### Permit of Authorization to Construct an On-Site Sewage Facility Permit Valid For One Year From Date Issued

Permit Number: 118888

2150 GOLF DR

### 118888.pdf Markup Summary

Subject: Deficiency
Page Label: 13
Charlemark: Unabase

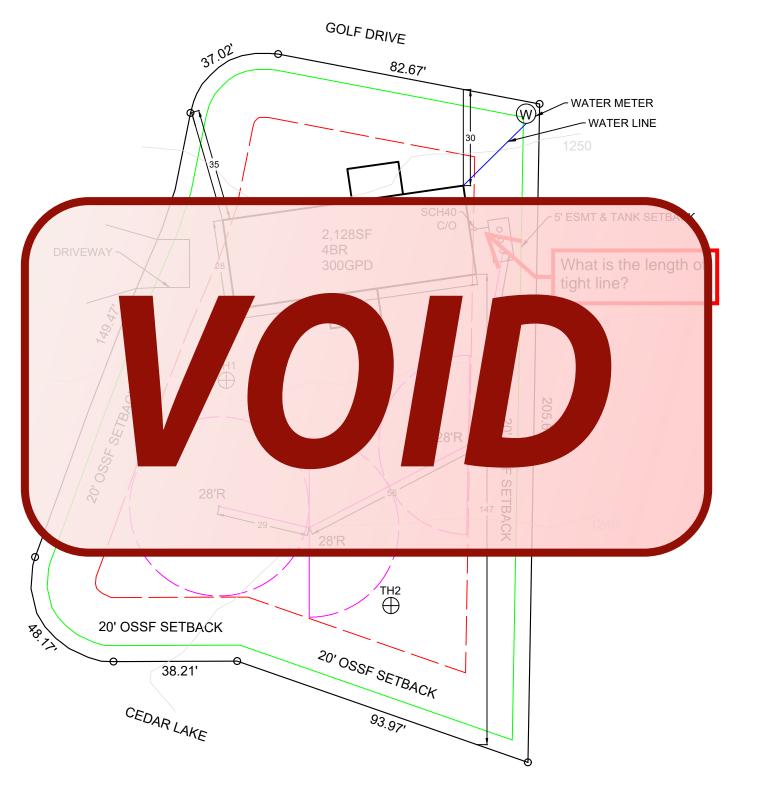
Thank you for your submission. We have reviewed the planning materials for the referenced permit application, and unfortunately, they are insufficient. To proceed with processing this permit, we require the following:

Checkmark: Unchecked Author: Brandon Mark Olvera Date: 8/28/2025 10:25:33 AM What is the length of tight

line?
